UR Universal Relay series

Revision 4.20 release note

GE Publication Number: GER-4029

- Affected products: UR Universal Relay series
- Date of release: June 30, 2004
- Firmware revisions: 4.20
- Boot code revision: 3.01

N Breaker Arcing Current: the breaker arcing current feature to include calculation of fault duration 12290

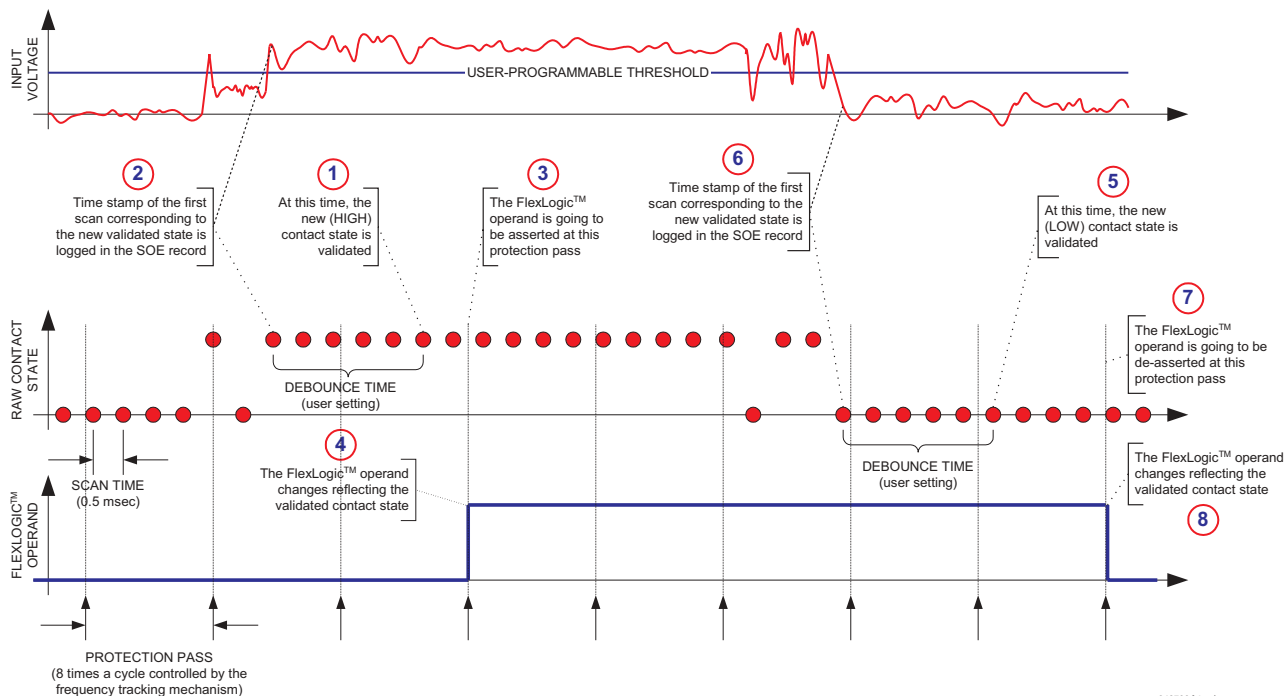
A new feature has been added to the Breaker Arcing Current function that performs fault duration calculations. Fault duration is defined as the time between the operation of the disturbance detector (occurring before a trigger) and the reset of a low-set overcurrent detector.
